Hi-Fi Products Service Bulletin

Model: SEN-205, TC-FX205, TC-FX430

No. 477

Subject: Replacement Cassette Holder Available

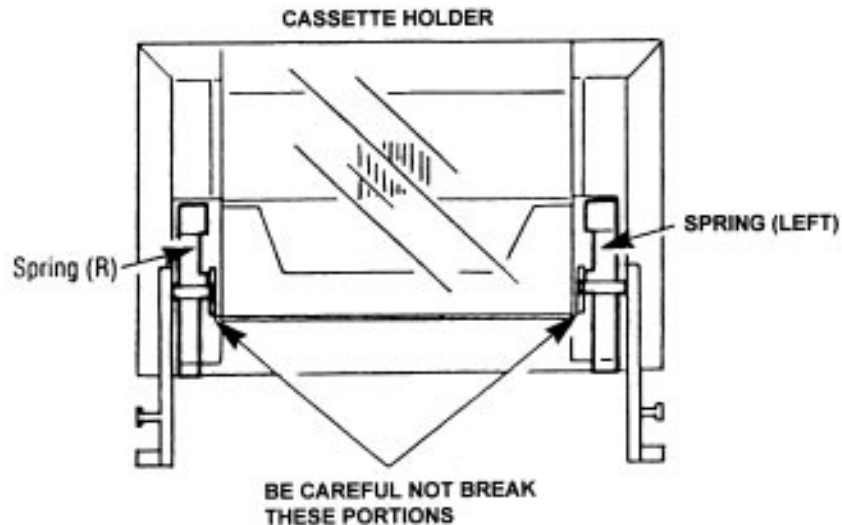
The original cassette holder (A-2173-013-A or X-3318-918-1) is no longer available. Use the following part number when ordering X-3318-945-1.

To correctly mount the replacement Cassette Holder, it is necessary to add the Left Spring (3-307-371-00) and the Right Spring (3-307-372-00). See diagram below.
